<u>APP/22/00427 - The Pavilion and Recreation Ground, Horndean Road,</u> <u>Emsworth</u>

<u>Updates</u>

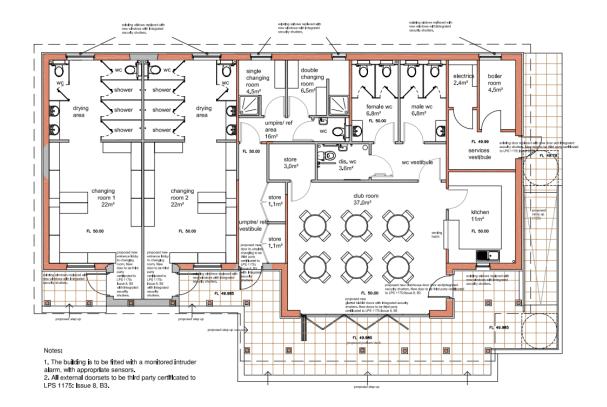
1. All external doorsets should be third party certificated to LPS 1175: Issue 8, B3.

2. The building should be fitted with a monitored intruder alarm, with appropriate sensors to detect an attack at the earliest opportunity.

3. Any changes to the exterior of the building should not facilitate gaining access to the roof. A small passage way exists between the western elevation of the building and the park keeper's lodge, this is a place within which a person might lie-in-wait unseen. To reduce the opportunities for crime and disorder, a robust visually permeable barrier (Perhaps vertical railings) should be fitted at each end of the passage way. One of the barriers should be a gate to facilitate access to the passageway. The barriers should be constructed in such a fashion that locks, handles, bolts etc. do not facilitate climbing the barrier. The barrier should be at least 1.8m high.

The applicant has amended the doors to show these meet the required standards, they have confirmed an intruder alarm is fitted and hat the proposal would not allow increased access to the roof. The fencing down the side is not deemed necessary at this point, noting the set in doorway would be removed from the plans, helping to alleviate any potential hiding spaces. The proposal does not result in increased hiding space from existing.
